## BIRD IN HAND GOLD PROJECT

### SUBMISSION

Phil Schmidt  
11 South Ridge Road  
Woodside SA 5244

The following figure shows the locations and types of MAR in Australia 2015 (Waterhouse, Tuff, & Usher, 2017)

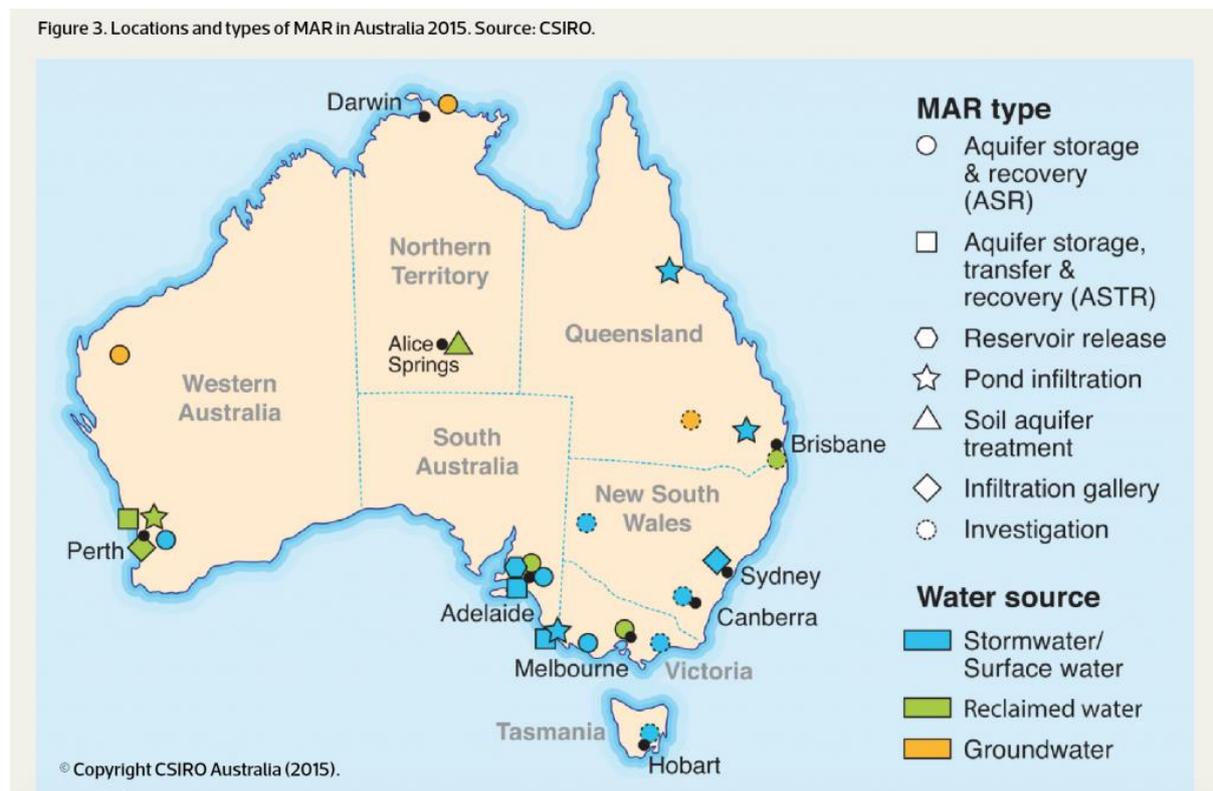
It shows that there are only 2 MAR mining projects being used in Australia that are using groundwater. Neither of these are in circumstances similar to the proposed system at this mine. The one in WA – Cloudbreak – is a brackish aquifer in the middle of the Pilbarra with no other users of the aquifer, not a fully allocated fractured aquifer – not comparable.

I have been unable to find details of the one in the Northern Territory however the geology there is very different to that in Woodside.
